**OFFICE OF NEW REACTORS**

**ASSESSMENT OF WHITE PAPER SUBMITTALS ON  
DEFENSE-IN-DEPTH; LICENSING-BASIS EVENT SELECTION, AND SAFETY  
CLASSIFICATION OF STRUCTURES, SYSTEMS, AND COMPONENTS  
(REVISION 1)**

**NEXT GENERATION NUCLEAR PLANT  
PROJECT 0748**

**Figure 1 Proposed dose acceptance limits for the NGNP safety analyses  
(Source: Figure 3 in the NGNP LBE white paper)**

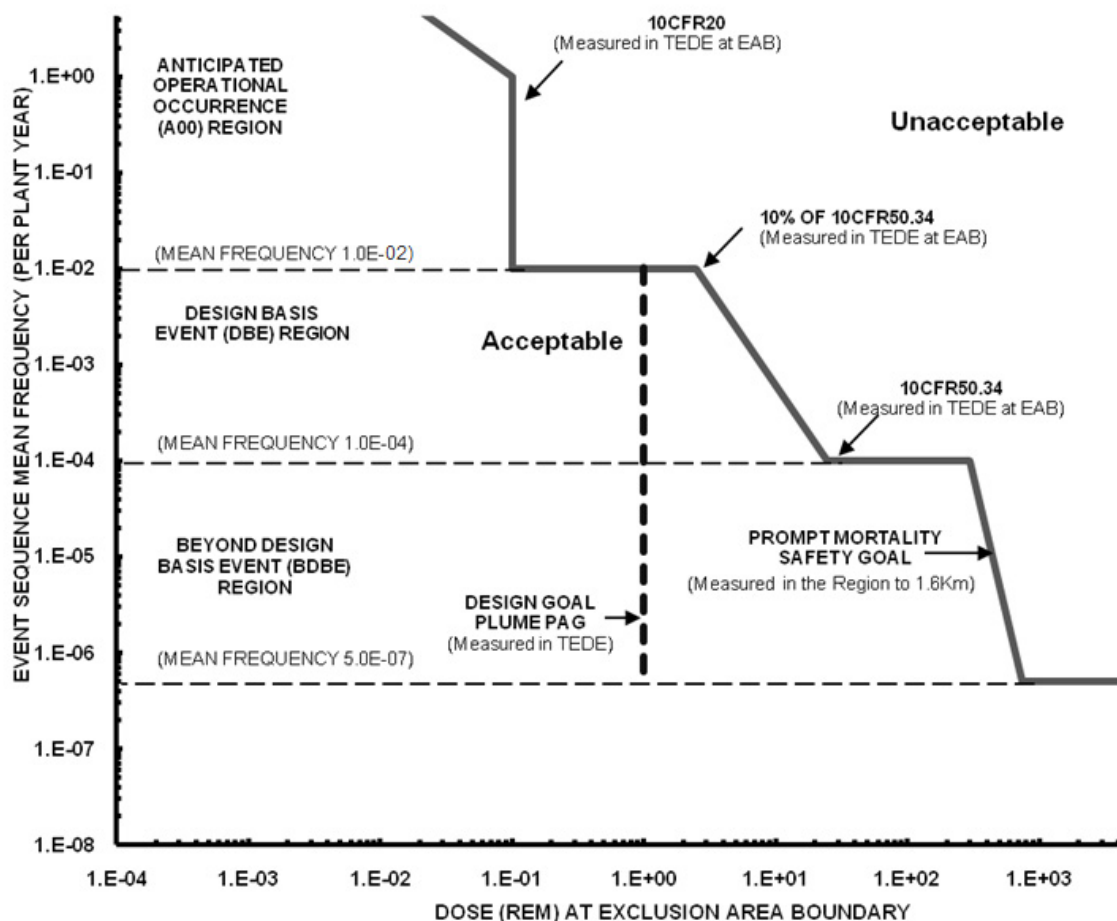
DOE/INL proposes dose acceptance limits on the LBE consequences and the analysis basis for the LBE categories, which are generally consistent with the NGNP LS with several significant exceptions. Figure 1, a reproduction of Figure 3 from the NGNP LBE white paper, depicts the proposed dose acceptance limits for the NGNP safety analyses.

The event frequency versus dose consequence acceptance line shown in Figure 1 is generally referred to as an “F-C curve.” For events in the AE frequency region, construction of the proposed F-C curve is based on the dose limits in 10 CFR Part 20. For events in the DBE frequency region, construction of the proposed F-C curve is based on the dose limits in 10 CFR 50.34.<sup>7</sup> For events in the DBE region, the proposed F-C curve has been constructed in such a manner that would allow a reduced dose as DBE frequency increases. For the DBAs (which are selected and derived from the DBEs), DOE/INL proposes that dose criteria in 10 CFR 50.34 apply (i.e., without reduction). For events in the BDBE frequency region,

The staff recognizes that there are a large number of ways to construct an F-C curve that use the dose acceptance criteria of existing NRC regulations and applies them to inferred frequency ranges for the event categories to meet the above stated objectives. For example, the proposed frequency consequence curve shown in Figure 3-3 in NUREG-1860 was developed in connection with the NRC staff's feasibility study for a risk-informed and performance-based regulatory structure for future plant licensing. The development of the F-C curve shown in Figure 3-3 of NUREG-1860 was done using the same LWR regulations that DOE/INL used to develop its proposed F-C curve. The development of the F-C curve in NUREG-1860 also includes consideration of additional dose acceptance criteria associated with national and international radiological health standards.
